## PRODUCT CHANGE NOTIFICATION

#PCN-DCT-JJ00-10

Business Unit	Product Line Code	Type of Change	Action	Date of issue
DCT	262	Mechanical	Notify Distributors and Field	07/08/2010

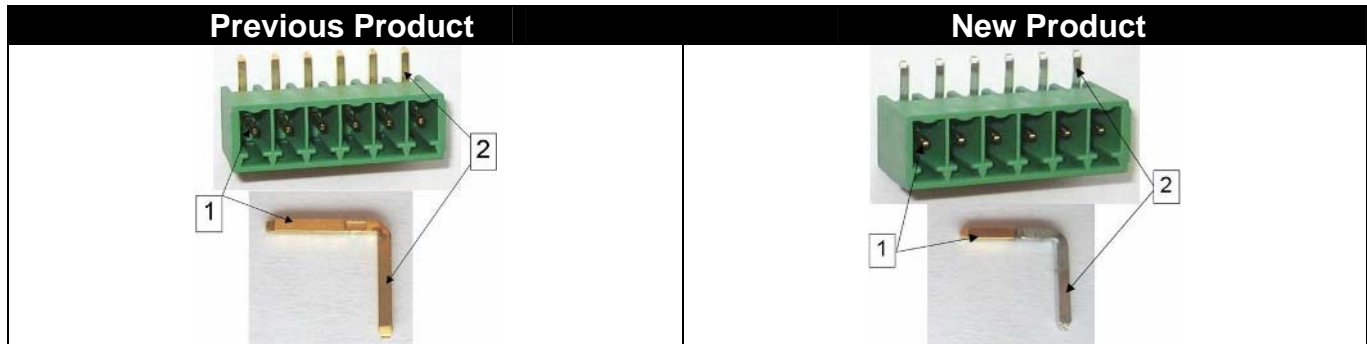
The metal pins of the horizontal MC 1,5 header will change from a completely gold-plated to a partial gold-plated surface. For a better solderability of the article, the solder area (2) (see pictures) of the pins get a lead-free tin plating. The surface of the contact area (1) is still gold-plated. Dimensions and technical data are not affected by this modification.
